Memorandum to the City of Markham Committee of Adjustment

File: A/081/21
Address: 35 Houser Street – Markham, ON
Applicant: Shailesh Patel and Hemangini Patel
Agent: YEJ Studio and Consulting Inc (Amr Robah)
Hearing Date: July 21, 2021

The applicant is requesting relief from the following “Residential Two Exception *99 (R2*99)” zone requirements under By-law 177-96, as amended, as it relates to a sunroom addition located in the rear yard. The variance requested is to permit:

SITE PLAN		A-02
Drawn by	A.H.	
Project number	21 RE100-4	
Date	2021.01.27	Scale 1/8" = 1'-0"

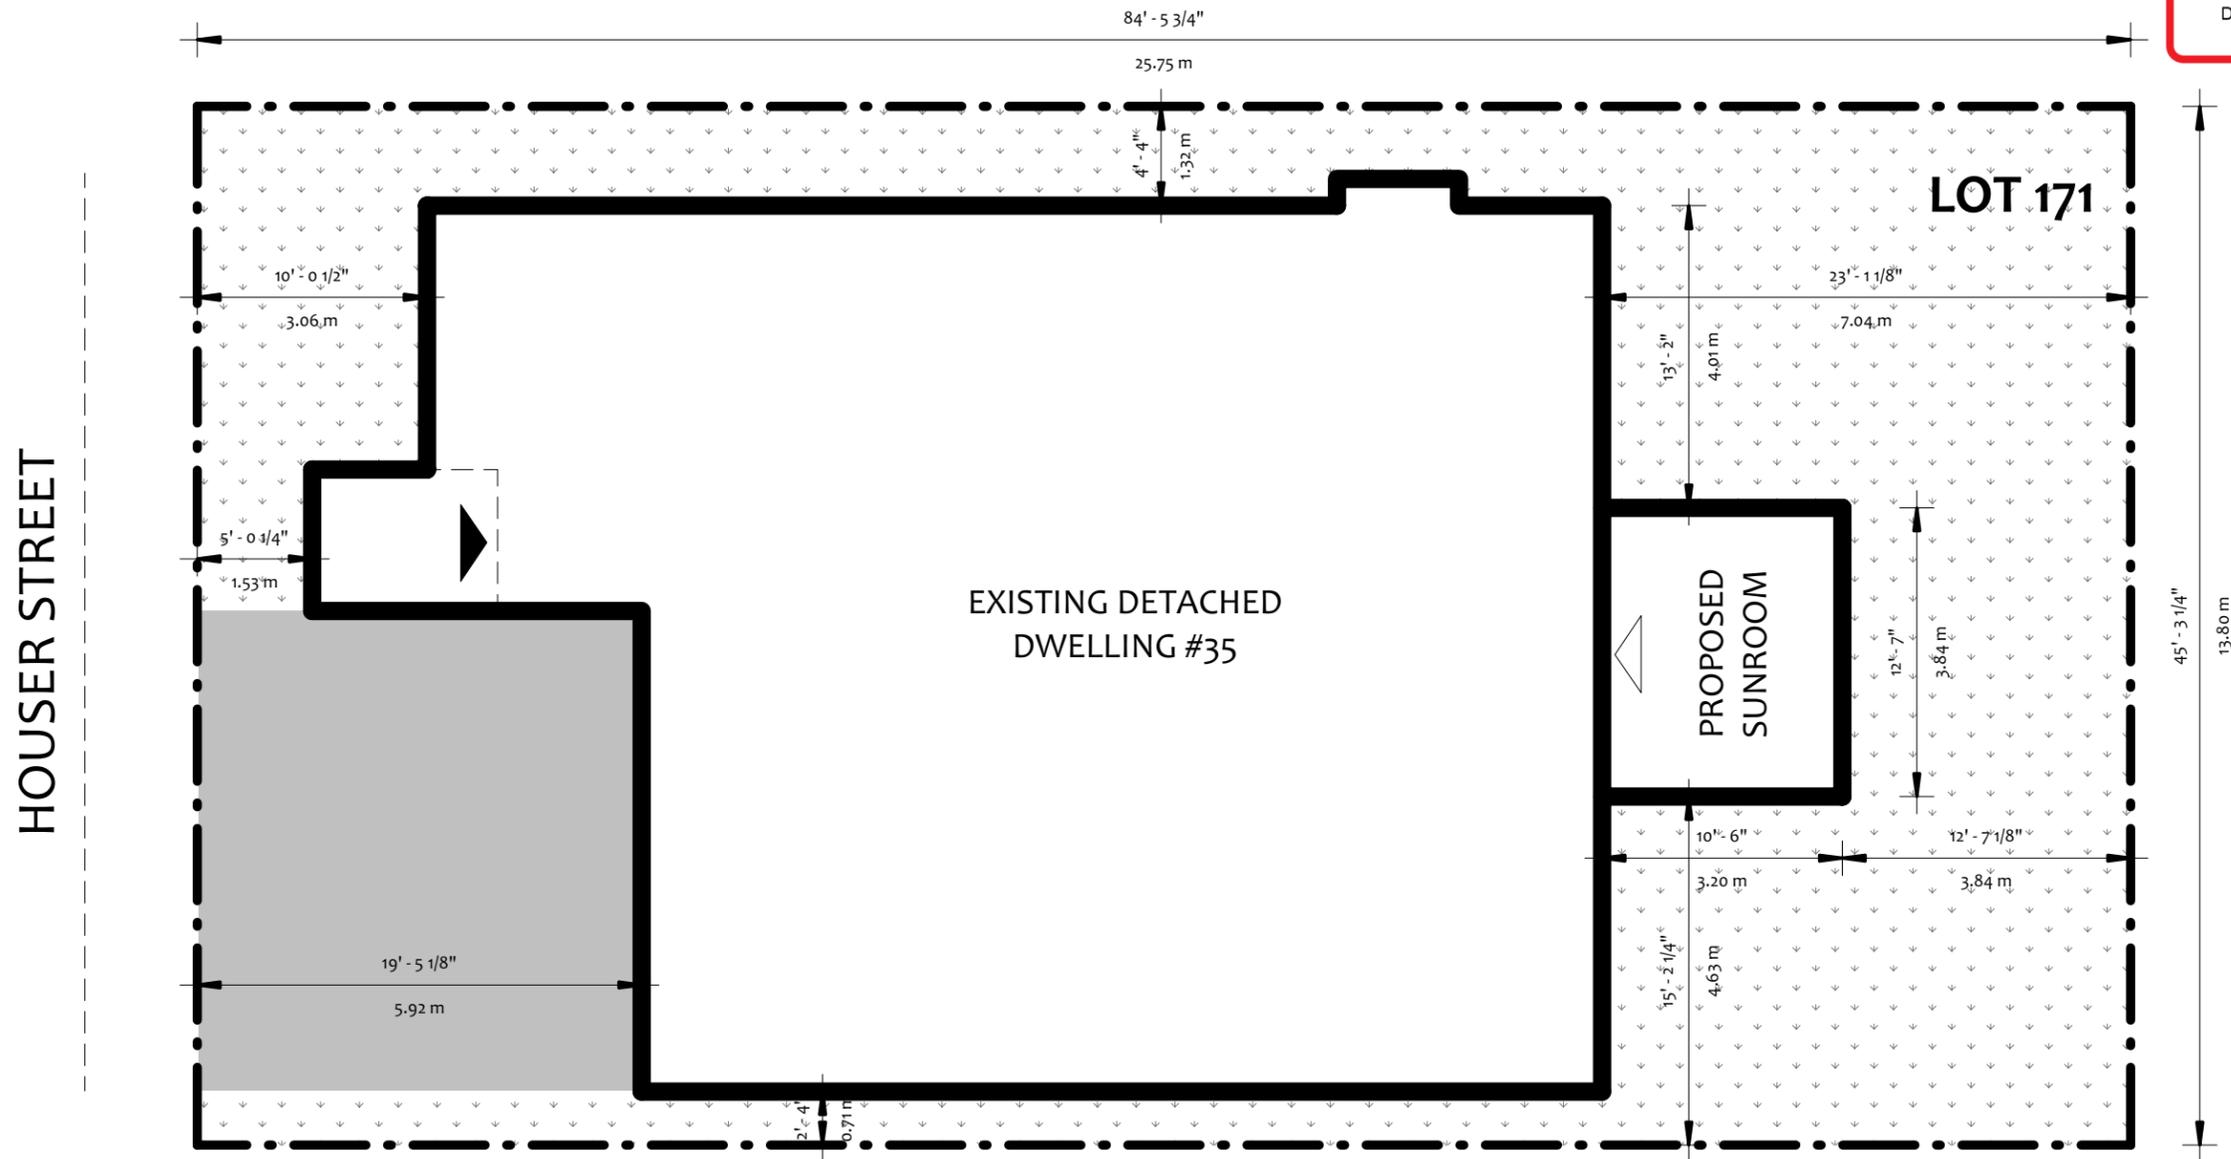
The applicant is requesting a minimum rear yard setback of 3.84 m (12.60 ft), whereas the By-law requires a minimum rear yard setback of 7.0 m (22.97 ft). This is a reduction of 3.16 m (10.37 ft).

The requested variance to permit the sunroom in its location extends 3.20 m (10.50 ft) beyond the main rear wall of the building, or almost halfway into the rear yard setback. The width of the proposed sunroom is 3.84 m (12.60 ft), and the majority of the main rear wall of the building on either side of the sunroom has a rear yard setback of 7.04 m (23.10 ft) which is in compliance with the rear yard setback requirement, and which minimizes any potential impact of the proposed sunroom on adjacent properties.

Staff are of the opinion that given the one-storey height, central location of the proposed sunroom which does not extend along the entire width of the main building, and remaining useable rear yard, the requested variance is appropriate, and minor in nature. Staff recommend that the conditions detailed in Appendix "A" be adopted by the Committee in the event of approval.
